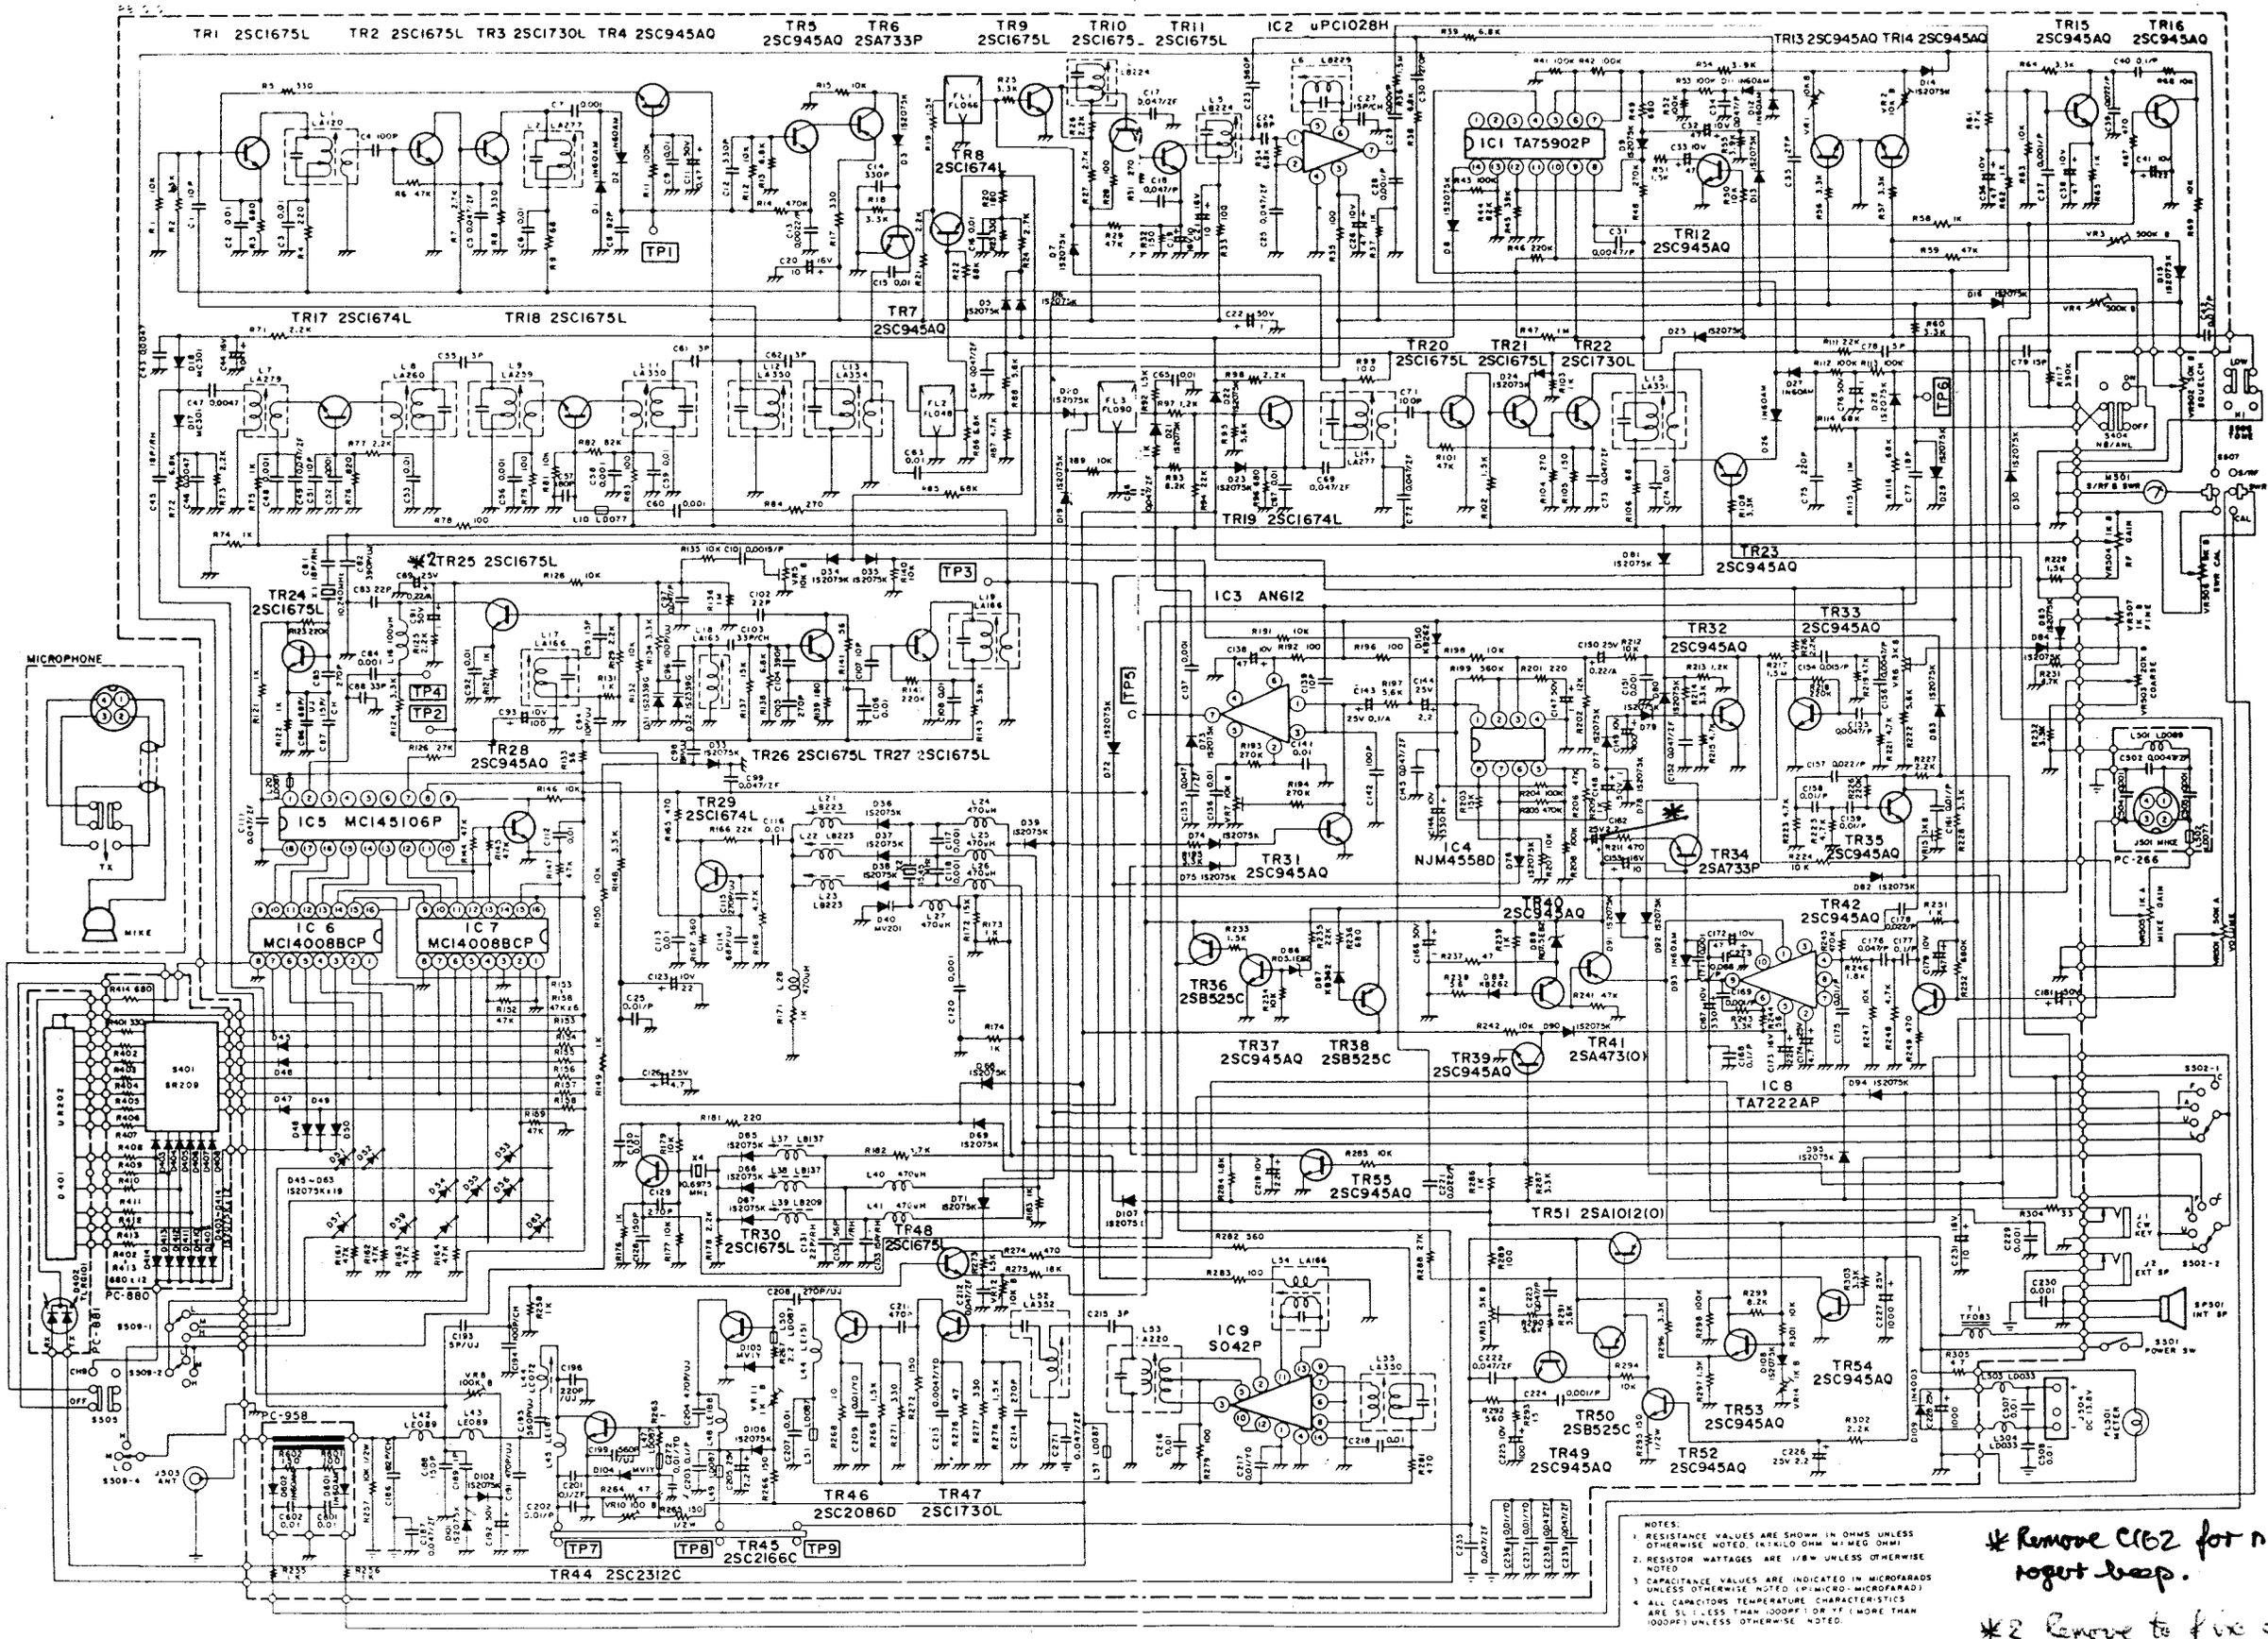
*Remove C162 for no squelch beep.

*2 Remove to fix audio tone on UHF/VHF low channels (10 meter)
